NW. Cor. 16-31-15
31.5' N. to 1 1/2" pipe
34.2' S.E. to Hdge. Cor. Post.

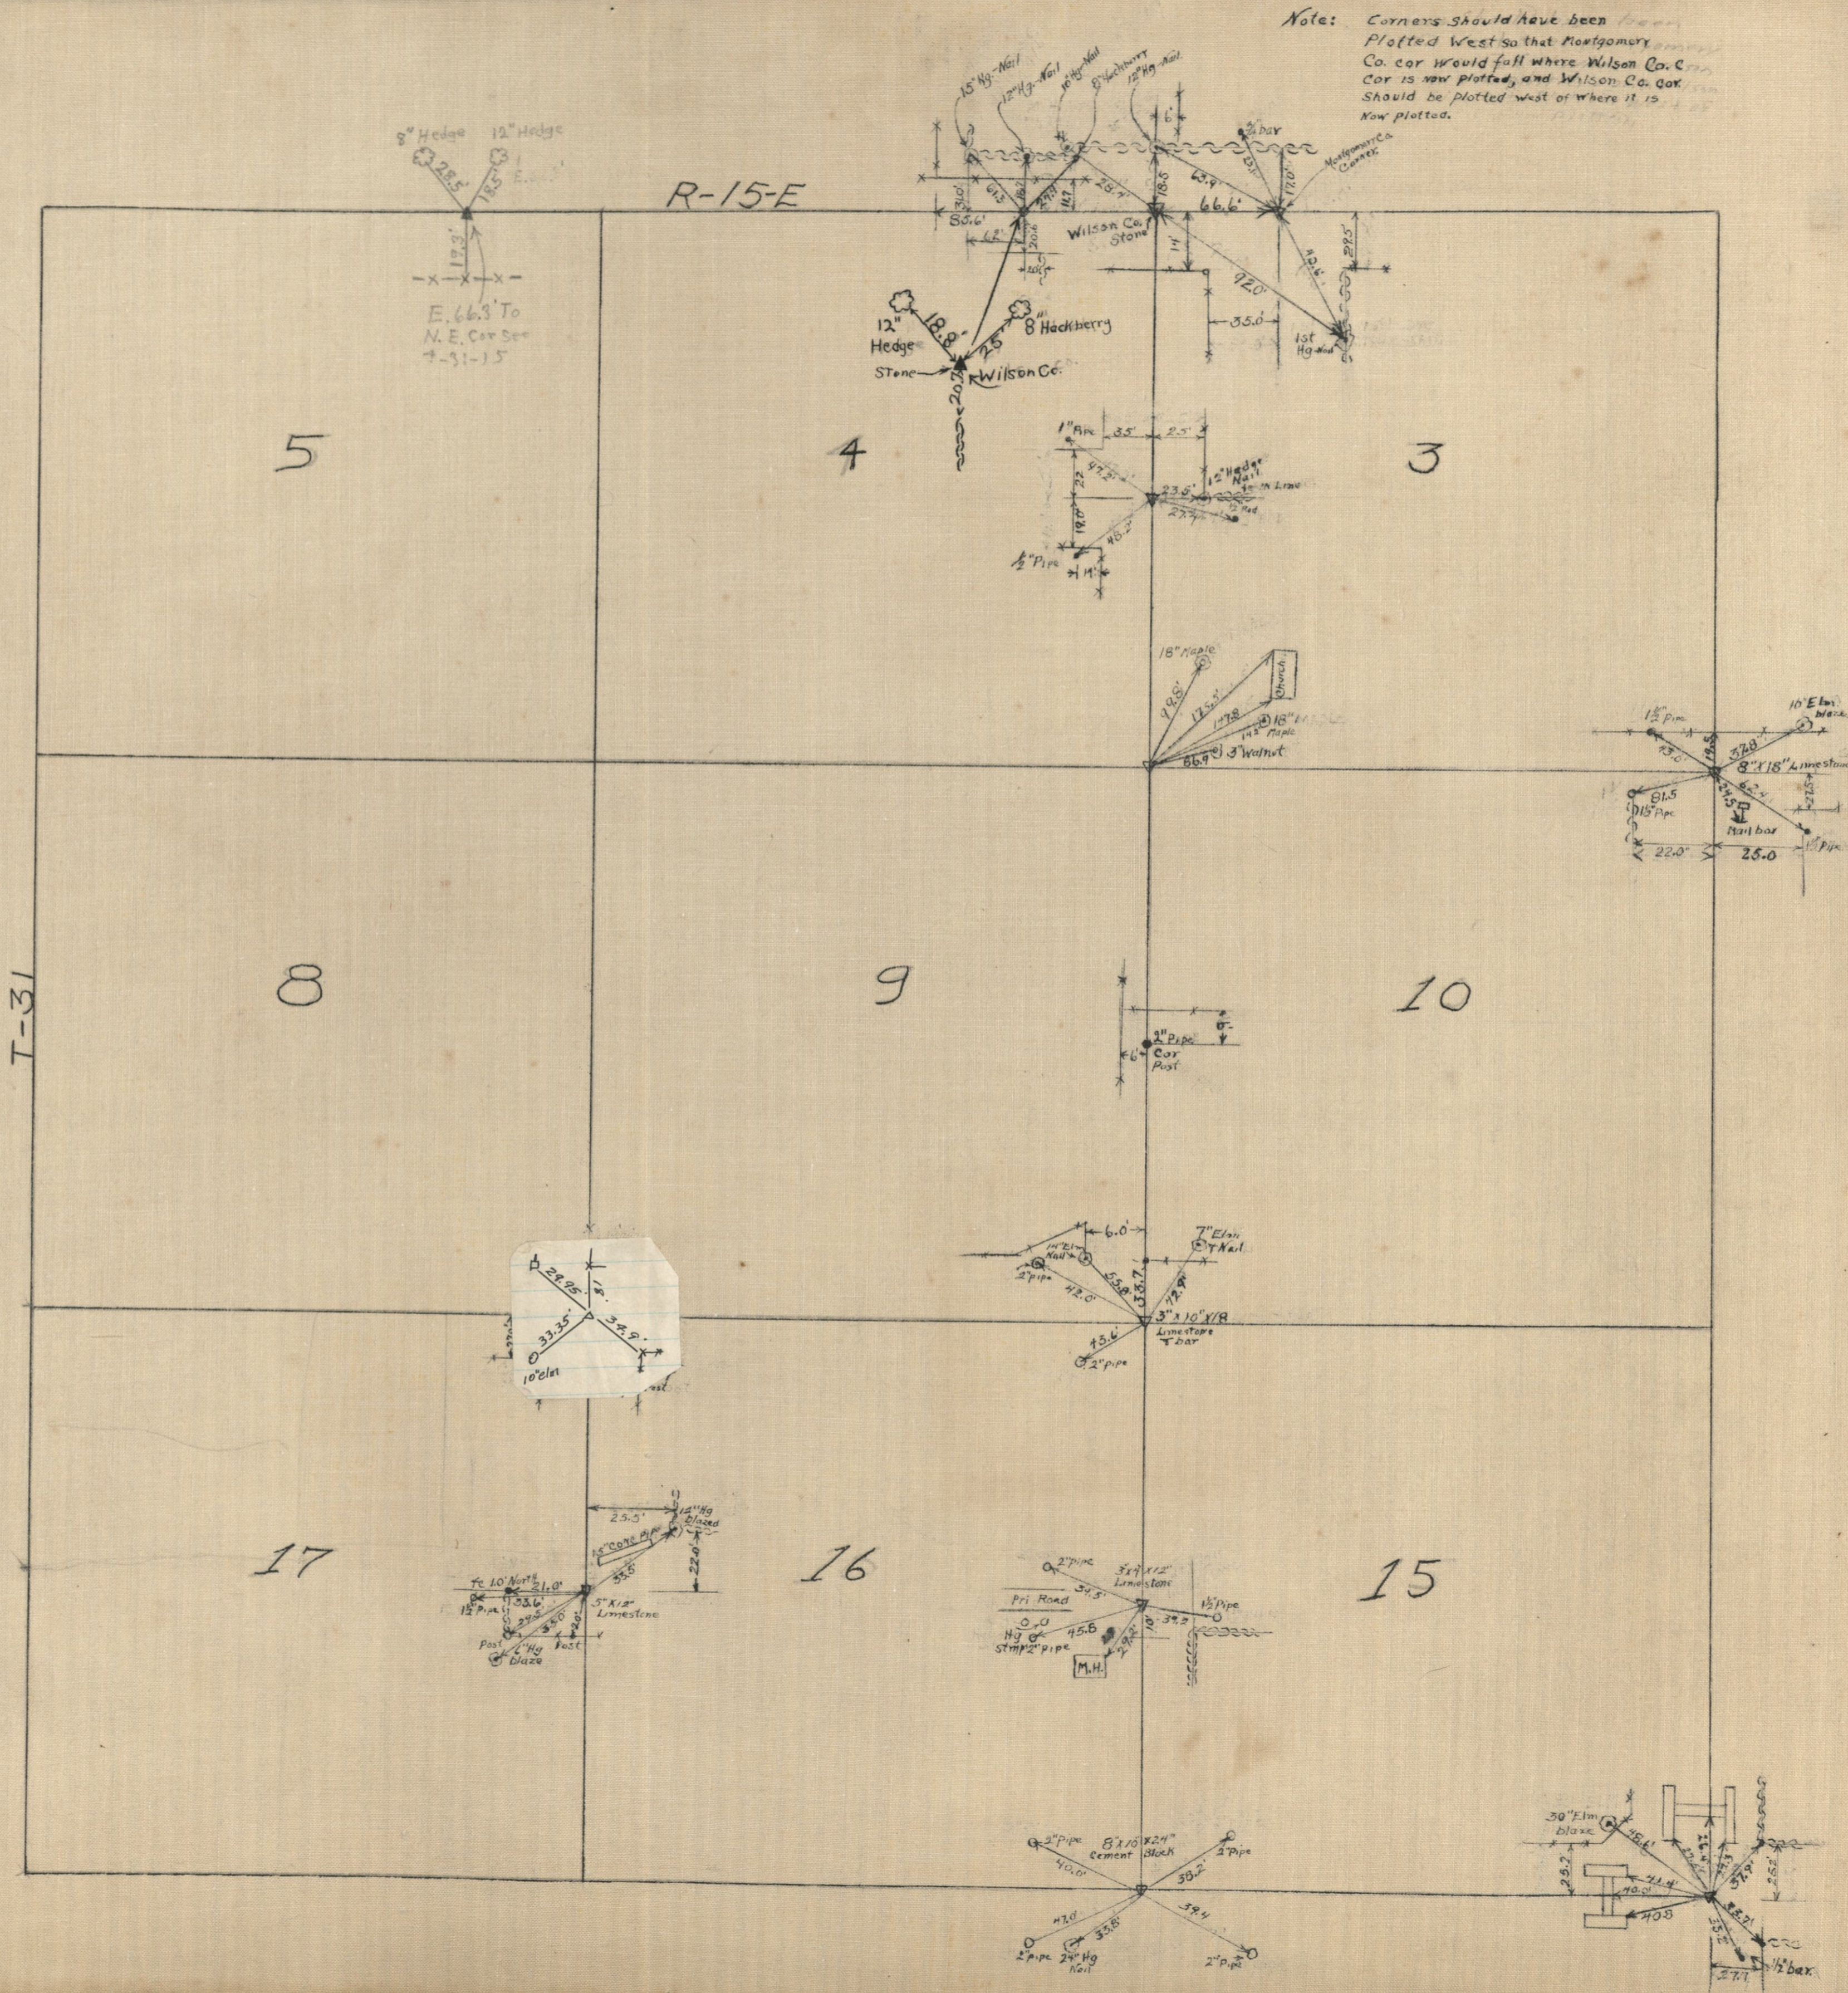
Note: Corners should have been Plotted West so that Montgomery Co. cor would fall where Wilson Co. cor is now plotted, and Wilson Co. cor should be plotted west of where it is now plotted.
